Model: Russian-C2		Date: 24-Oct-01	No.: RB022001
Subject: The fax function does not work		Prepared by: S. Tomoe	
From: Technical Services Dept., GTS Division			
Classification:	<input checked="" type="checkbox"/> Troubleshooting	<input type="checkbox"/> Part information	<input type="checkbox"/> Action required
	<input type="checkbox"/> Mechanical	<input type="checkbox"/> Electrical	<input type="checkbox"/> Service manual revision
	<input type="checkbox"/> Paper path	<input type="checkbox"/> Transmit/receive	<input type="checkbox"/> Retrofit information
	<input type="checkbox"/> Other ()

Model: Russian-C2		Date: 26-Oct-01	No.: RB022002
Subject: Major differences between Russian-C1 and Russian-C2		Prepared by: S. Tomoe	
From: Technical Services Dept., GTS Division			
Classification:	<input type="checkbox"/> Troubleshooting <input type="checkbox"/> Part information <input type="checkbox"/> Action required <input type="checkbox"/> Mechanical <input type="checkbox"/> Electrical <input type="checkbox"/> Service manual revision <input type="checkbox"/> Paper path <input type="checkbox"/> Transmit/receive <input type="checkbox"/> Retrofit information <input checked="" type="checkbox"/> Ot

1. Pressure Roller

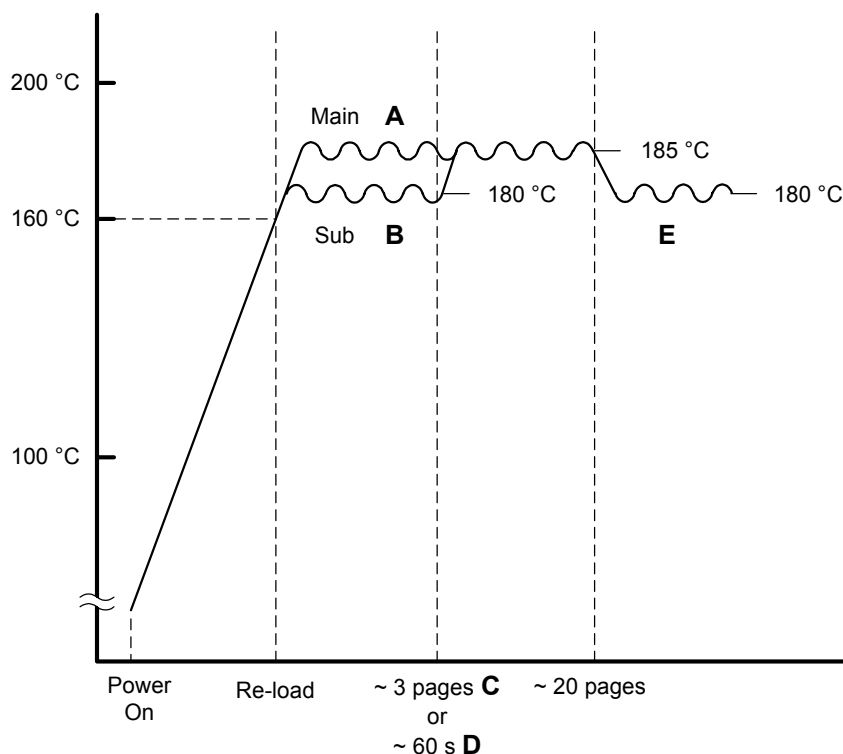
The diameter of the pressure roller has been increased.

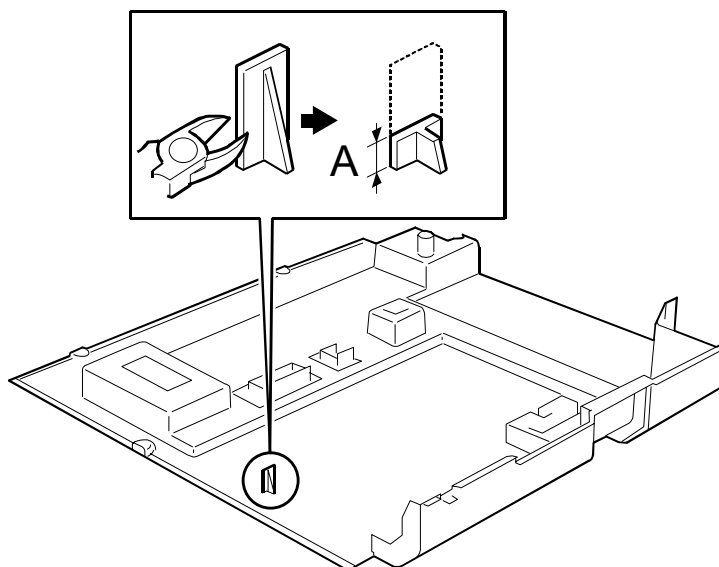
A rib on the Rear Covers produced at the factory in Korea (for machine code: B022-57) contacts the FCU bracket and prevents the cover from being installed.

The manufacturer had used the mold for the Russian-C1 to make the Rear Cover (which normally contains the rib).

- 1) SP5-113: Exp. Key Card (Add)
Exp. Key Card (Deduct)

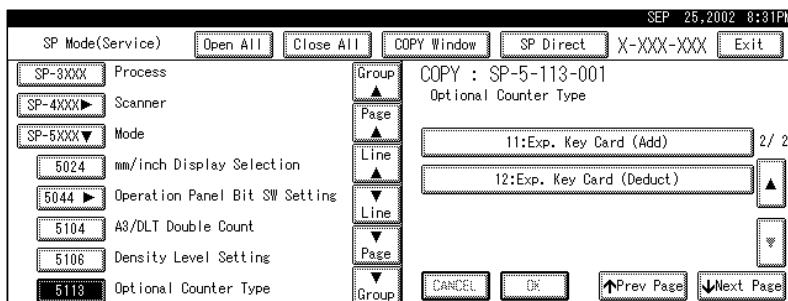
1. New SP and UP modes added to enable the feature:

BRIDGE UNIT (B417) ELECTRICAL COMPONENT LAYOUT

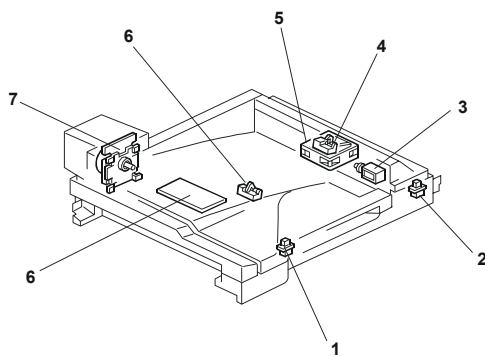
Please correct the connector numbers on the Bridge Unit point-to-point diagram, as shown on the following page.

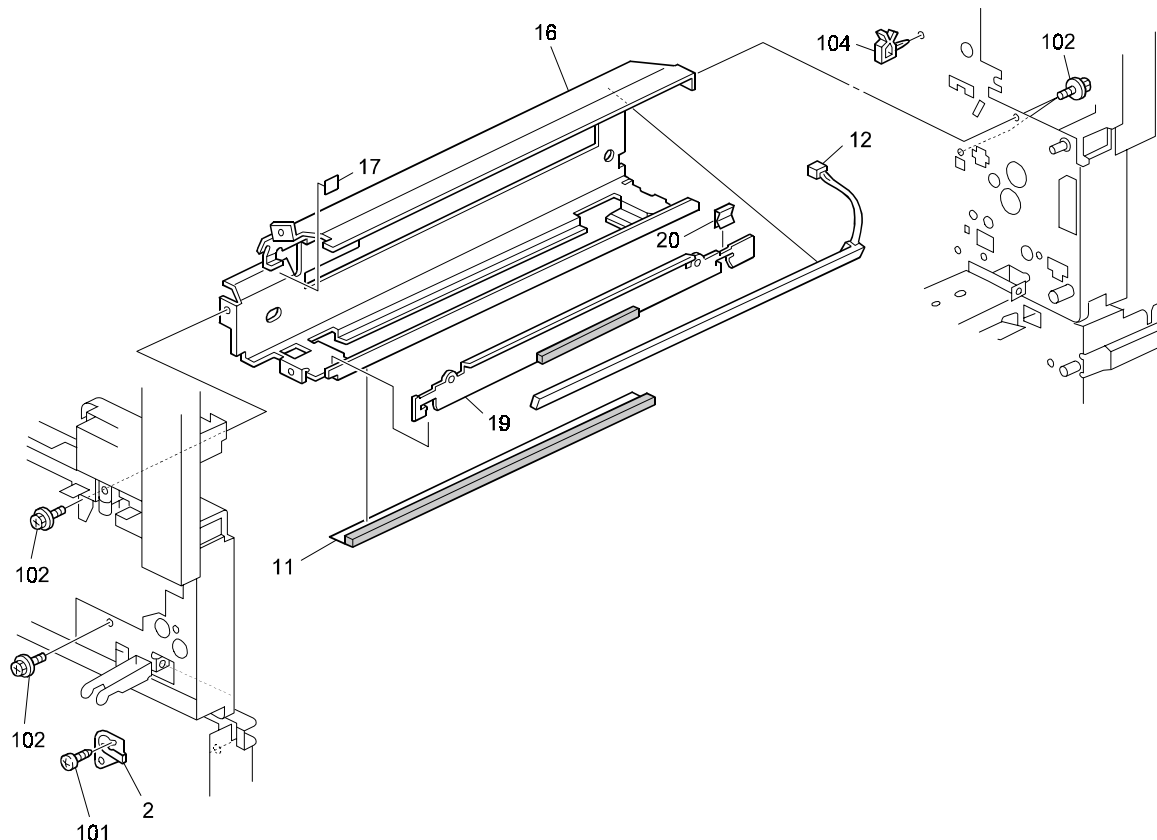
To increase Registration Roller cleaning efficiency and provide greater accessibility, the Mylar type Registration Roller Cleaner has been changed to a removable Cleaning Pad type.

In accordance with this change, the shape of the PCU Guide Plate has also been changed.

Important Note for Hot Roller Replacement

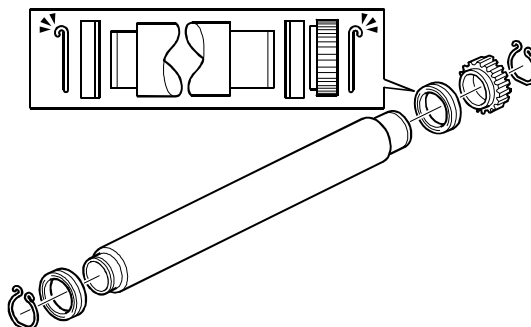
When you replace the hot roller, make sure to attach the C-ring in the **orientation shown below**. This helps the C-ring to hold the fusing roller more securely.
